Access Compliance Report

Public Rights-of-Way

Intersection ID: 52582	Main Street: NOBLES_AV	Cross Street: N/A	Location: NE
ADA ID: 3C93348870E0	Ramp Type: Perp	Initial Pass/Fail: Fail	Overall Compliance: No
Severity Score: 13.75			
Codes/Mitigation Info/Possible Solution		Field Measurements/Component Compliance

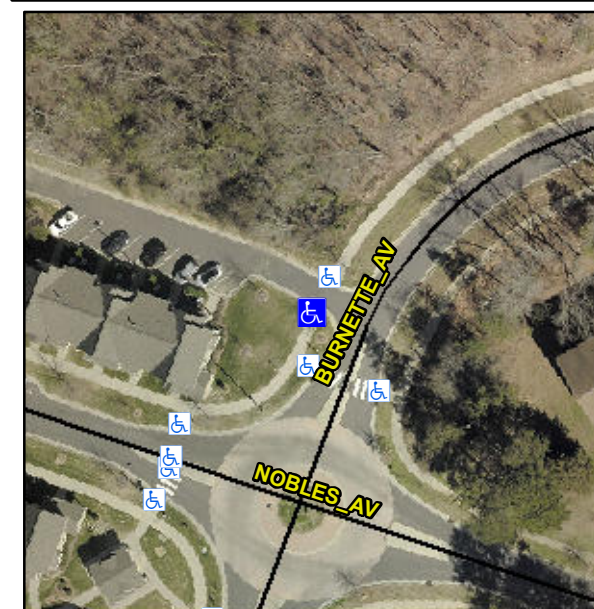
R304.2.2, R304.5.3

Compliance	Description	Data	Compliance	Description	Data
N/A	Ramp Length (in)	72.0	No	Ramp Slope (%)	9.5
Yes	Ramp Width (in)	72.0	No	Ramp XSlope (%)	2.9
N/A	Flare Type LT	N/A	N/A	Flare Type RT	N/A
N/A	Flare Slope LT (%)	N/A	N/A	Flare Slope RT (%)	N/A
N/A	Flare Traversable LT?	N/A	N/A	Flare Traversable RT?	N/A
N/A	Landing Length (in)	N/A	N/A	DWS Provided?	N/A
N/A	Landing Width (in)	N/A	N/A	DWS Contrast?	N/A
N/A	Landing Slope (%)	N/A	N/A	DWS Length (in)	N/A
N/A	Landing X Slope (%)	N/A	N/A	DWS Full Width?	N/A
N/A	Landing Curb? (Y/N)	N/A	N/A	DWS Offset (in)	N/A
N/A	Shared Landing?	N/A			
N/A	Gutter Ponding?	N/A	N/A	Gutter Slope (%)	N/A
N/A	Gutter Lip Ht (in)	N/A	N/A	Gutter X Slope (%)	N/A
N/A	Painted X Walk1?	No	N/A	Painted X Walk2?	N/A
	X Walk 1 Direction	To NE		X Walk 2 Direction	N/A
N/A	X Walk 1 Width (in)	N/A	N/A	X Walk 2 Width (in)	N/A
	X Walk 1 Slope (%)	0.2		X Walk 2 Slope (%)	N/A
	X Walk 1 X Slope (%)	2.5		X Walk 2 X Slope (%)	N/A

Remove & Replace Entire Ramp.
